CONSTRUCTION APPROVAL FOR CONTROL SERVICES CA2010102986 N.H. DEPARTMENT OF ENVIRONMENTAL SERVICES SUBSURFACE SYSTEMS BUREAU P.O. BOX 95, 29 HAZEN DRIVE, CONCORD, NH 03302-0095 THE PLANS AND SPECIFICATIONS FOR SEWAGE OR WASTE DISPOSAL SYSTEM SUBMITTED FOR:

24 hours prior to inspection at 964-8650. SEPTIC SYSTEM PLAN PROPOSED REPLACEMENT

182 MILL ROAD

RALPH & LINDA SHEROUSE OWNER:

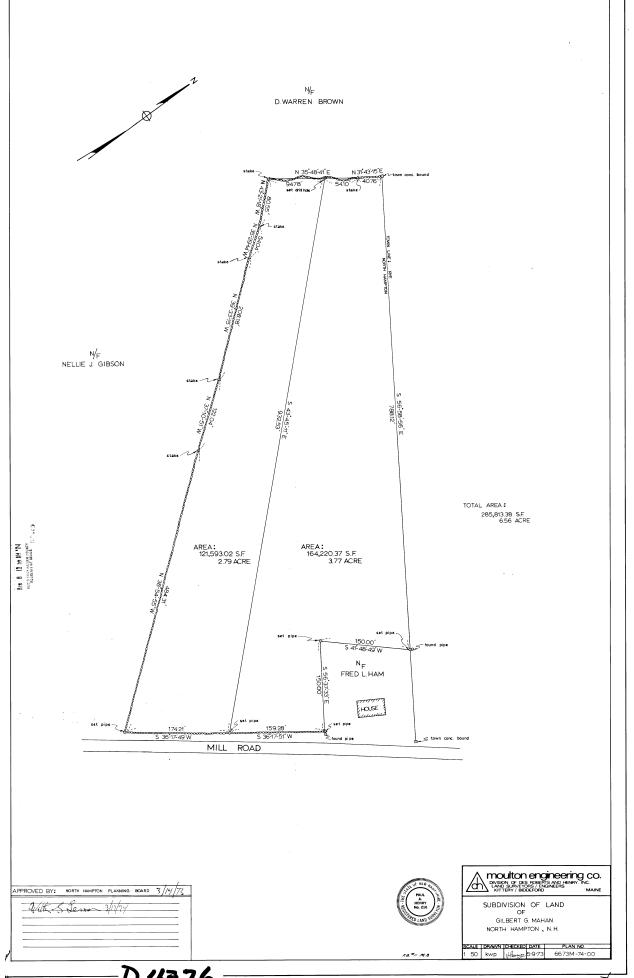
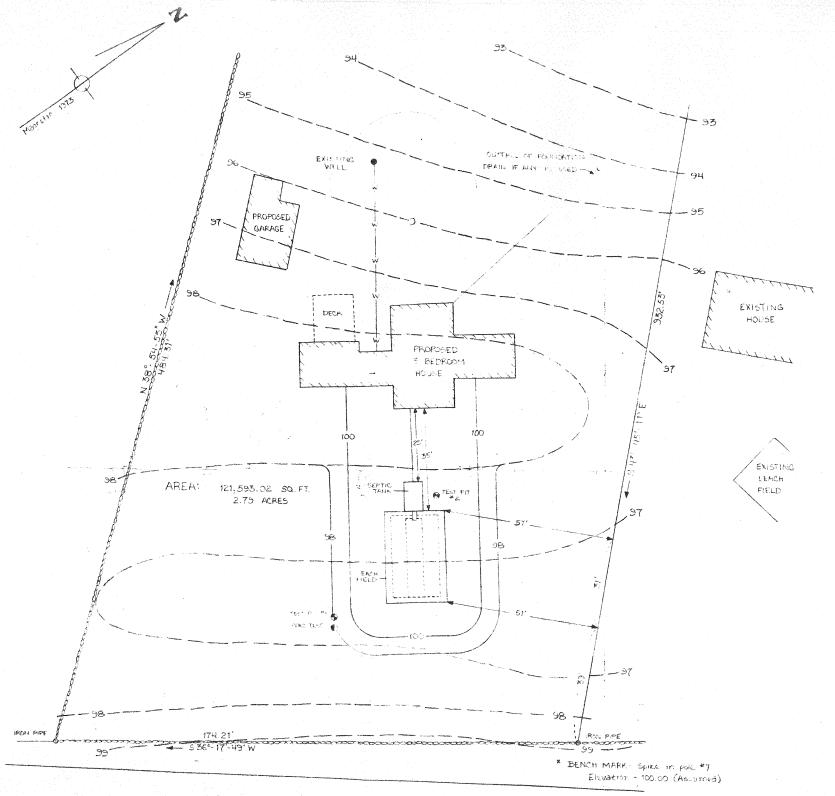
ADVISE YOUR CONTRACTOR OF REQUIRED CHANGES **BELOW CONDITIONS** IN PLANS AS INDICATED

1. THIS APPROVAL IS VALID FOR 90 DAYS FROM DATE OF SAID APPROVAL, PER ENV-WG 1003.22.

2. WAIVER GRANTED.

APPROVAL CORRECTED TO REMOVE PREVIOUS CONDITION #2. E.T. 12/01/10.
